DEPARTMENT OF COMMUNITY DEVELOPMENT SERVICES

TO: The Urbana Plan Commission

SUBJECT: Plan Case 2220-S-13, Request for waiver of Section 21-42.B of the Urbana Subdivision and Land Development Code regarding storm water management requirements for Country Side Second Subdivision

STORMWATER MANAGEMENT PLAN
COUNTRY SIDE SECOND SUBDIVISION,
 URBANA TOWNSHIP,
 CHAMPAIGN COUNTY, ILLINOIS

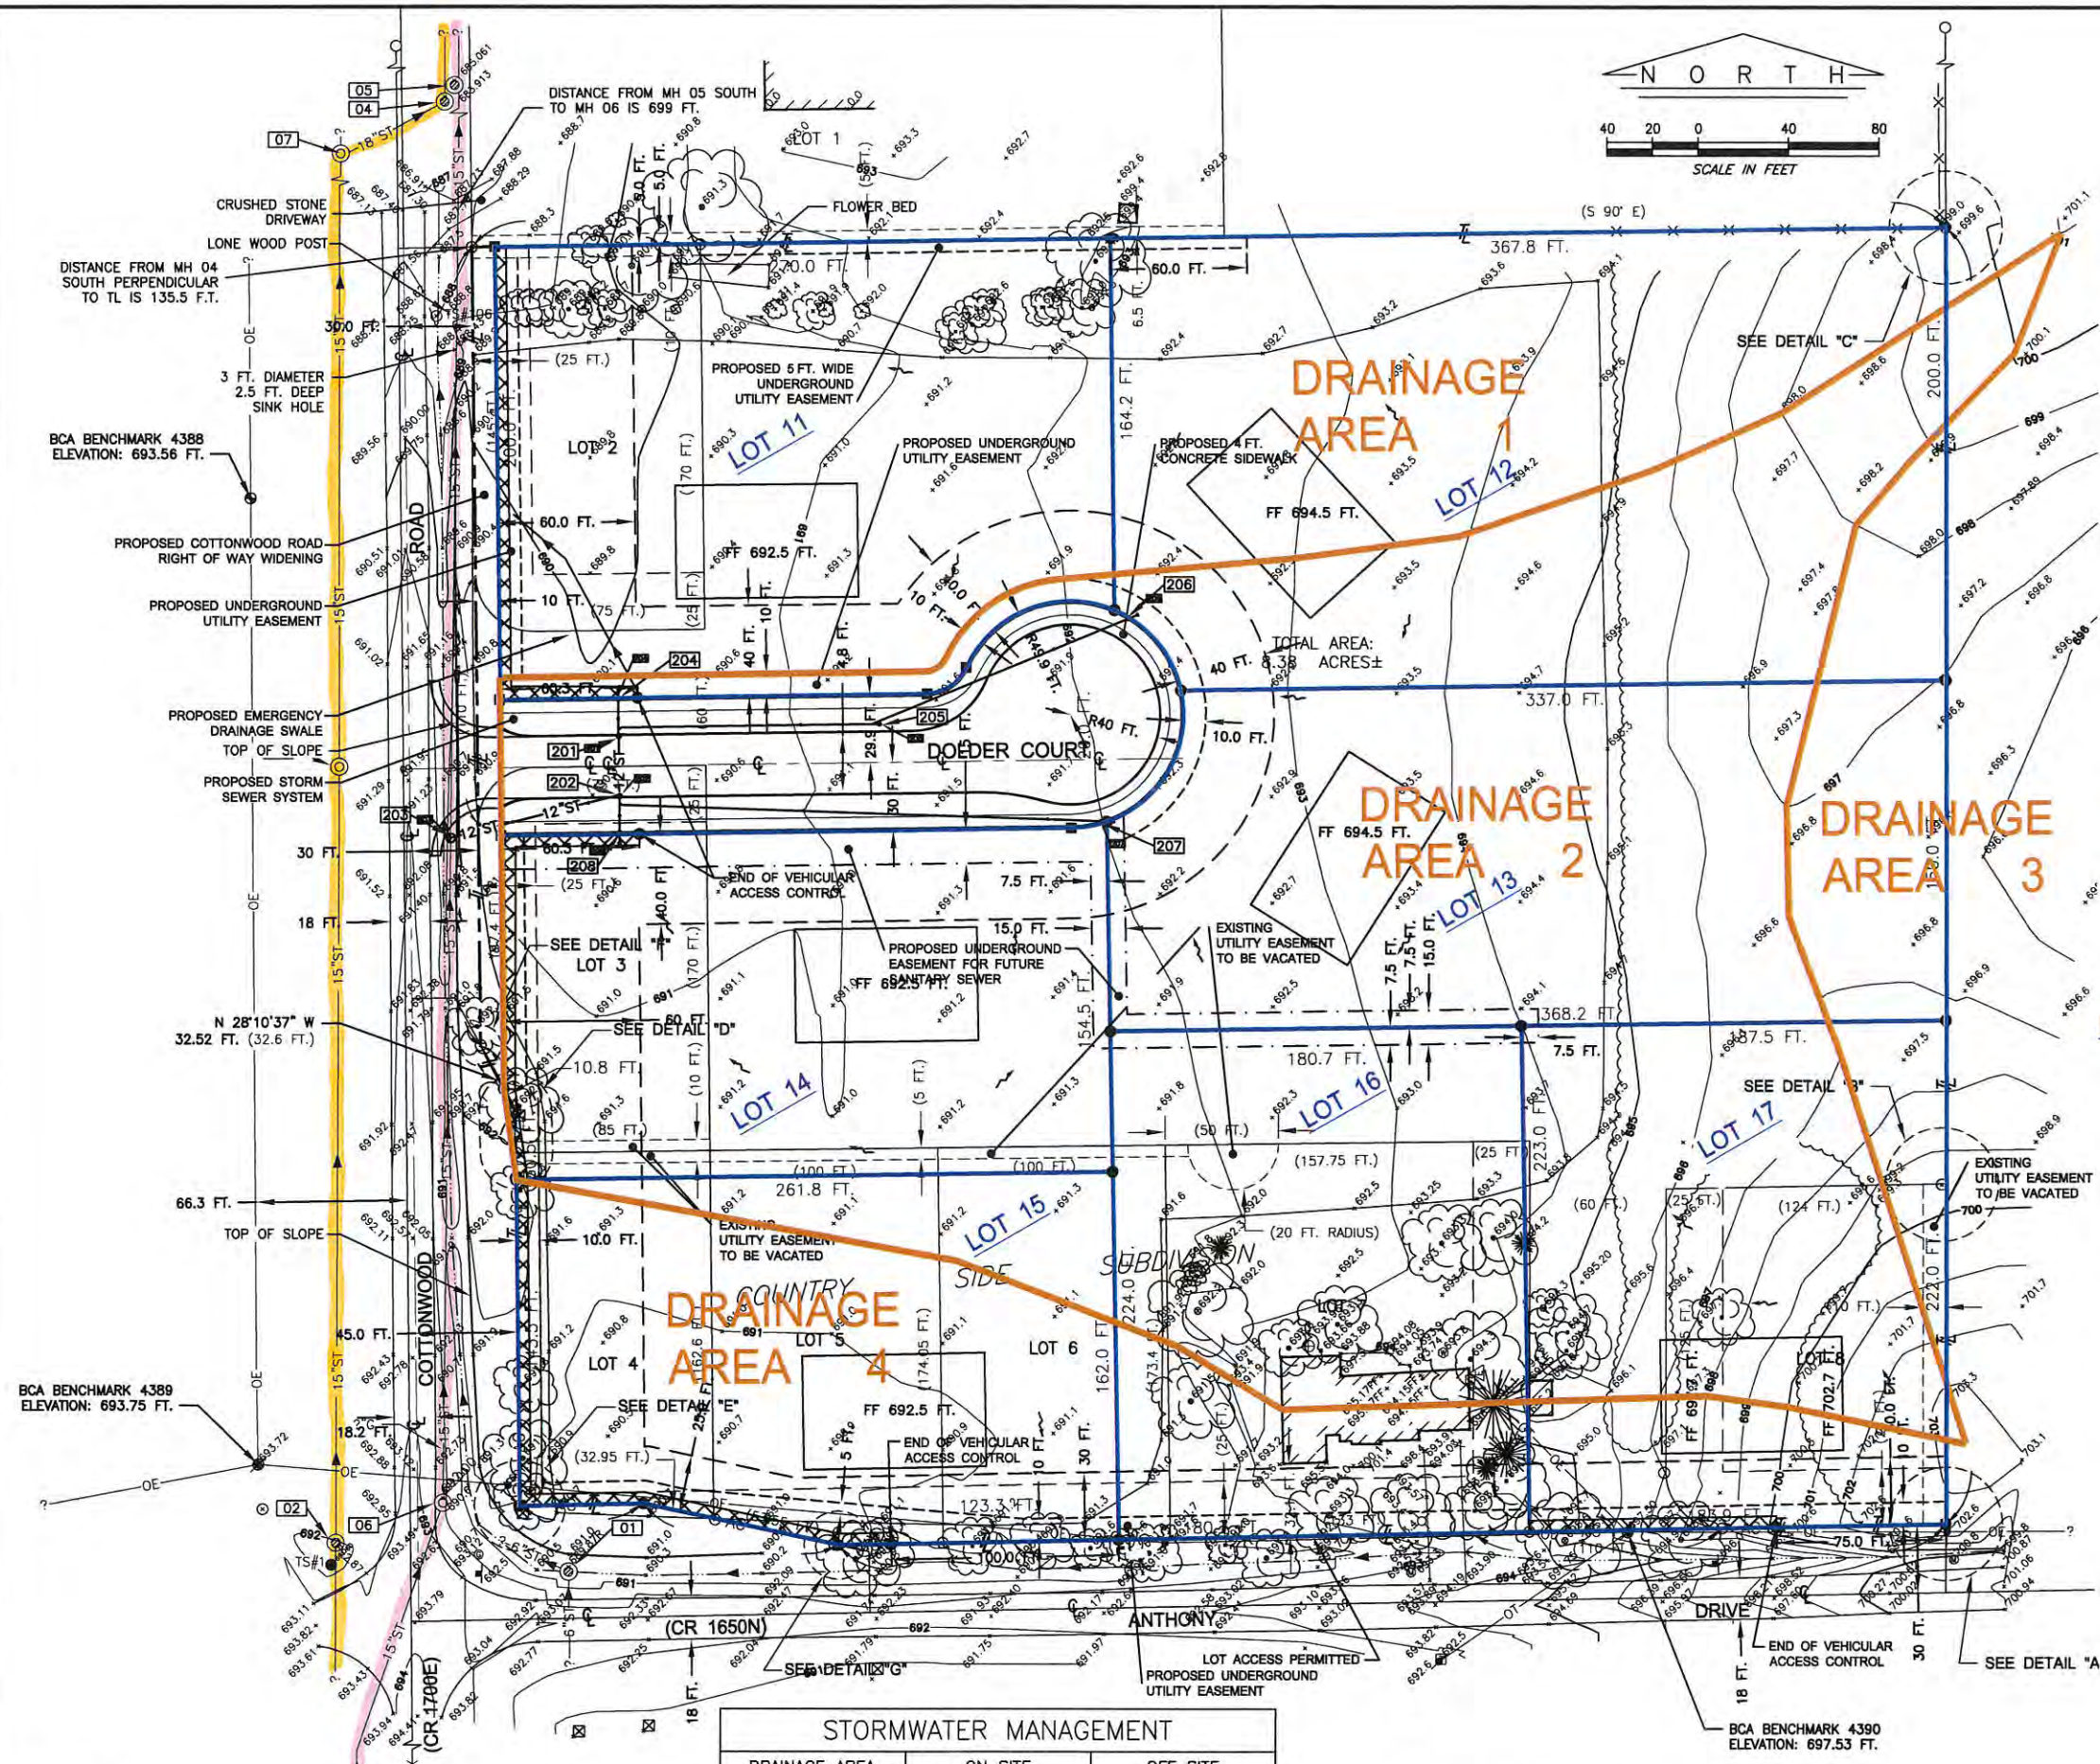
Staff's opinion is that there will be no decrease in the stormwater volume from predevelopment to post development conditions. Using published runoff curve numbers the pre-development agricultural runoff curve number is estimated at 0.30. The post development residential condition runoff curve number is estimated at 0.40. A higher runoff curve number results in an increase in stormwater runoff volume.

The stormwater calculations submitted by the petitioner's engineer show that the existing storm sewer does not have sufficient capacity for the five year post development storm event under gravity flow conditions. Staff's opinion is that there is not adequate storm sewer or ditch capacity to convey the five or 50 year design storm peak flows to the Saline Branch so the petitioner's request for waiver of stormwater detention requirements to allow the peak flows to reach the Saline more quickly are not valid. The existing ditches and storm sewer do not have the capacity to carry the peak flows from the site.

Staff disagrees with the claim of reduction in stormwater runoff volume. The conversion of agricultural land into single family residential development has typically increased the amount of water pollution over the existing agricultural use in stormwater runoff.
